ADDENDUM NO. 1

TO: PLANS AND SPECIFICATIONS FOR STATE OF MISSOURI

New Outdoor Firing Range
Missouri State Highway Patrol
Jefferson City, Missouri
PROJECT NO. R1806-01

ELECTRICAL POWER PLAN E102 ADDENDUM#1

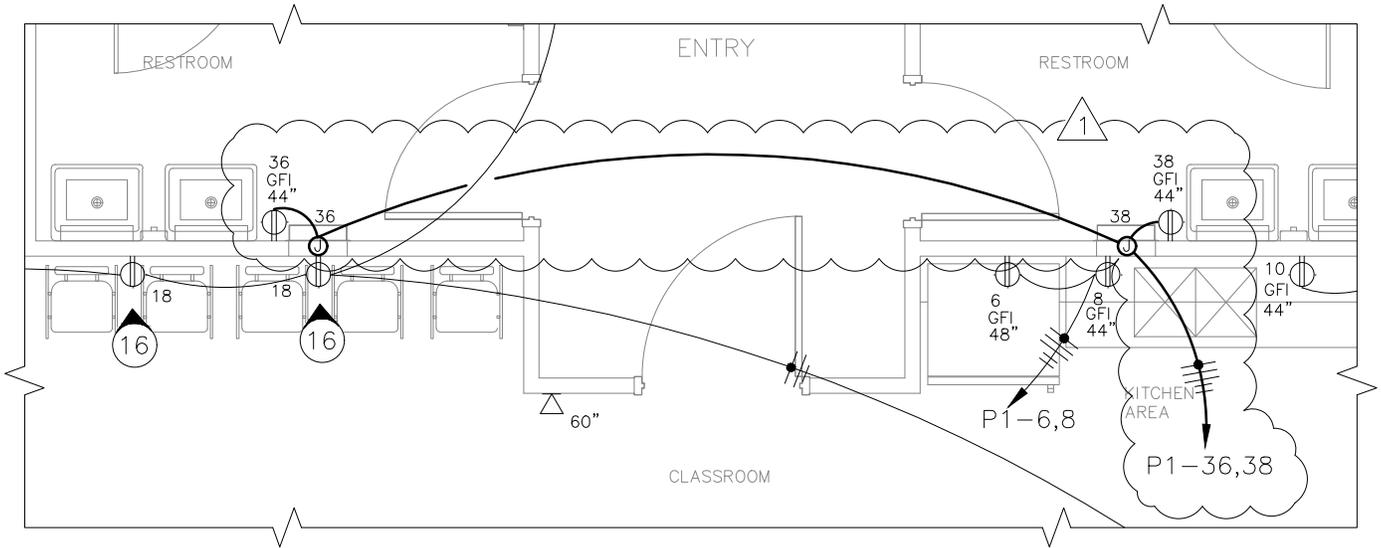
3. Sheet E-102

- a. ADD electrical receptacles as identified on the attached supplemental drawing AD #1/E-102.
